PLANNING DEPARTMENT

Staff Report & Recommendation

DRB0616-0039

2051 North Bay Road

Portion of the 1922 Amended Plat of Sunset Lake Subdivision (subject property Lot 27)

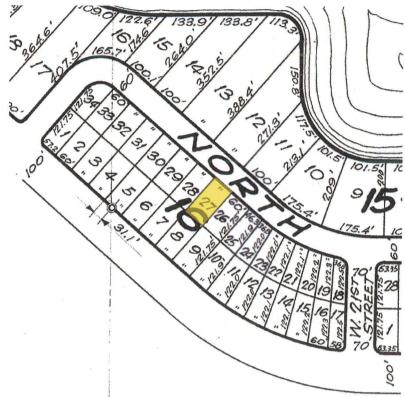
The subject property is an interior lot on a block within the Amended Plat of Sunset Lake Subdivision, which was historically platted on December 22, 1922 as a series of eight blocks between Alton Road and Sunset Lake. Block 16, of which the subject property is part and parcel of, was historically comprised of 44 lots, 25 of have 60'-0" wide frontages. The original building card for the 1930 construction identifies the structure was built on Lot 27 of Block 16. Sometime in the 1980s, the subject property acquired the southern 1.27' of the abutting property, Lot 28; this resulted in a lot with 61.27' of lot width for the subject property. The recent changes to Section 142-106 pertaining to side setback requirements require that lots with over 60'-0" in width have an increased setback of a minimum of 10'-0" along both side yards. Lots with 60'-0" or less of frontage have a minimum of 7'-6" required side setback. This would require the subject property, with 1.27' (or 14") of additional frontage to offset the building envelope an additional 5'-0" (2'-6" for each side). Without the granting of this variance, the construction of the building on the lot would be more restrictive than its immediate neighbors and the site could not be developed as other lots in the same district and same platted subdivision. The size of the property and its current parallelogram shape are the same original parcel geometric configuration.
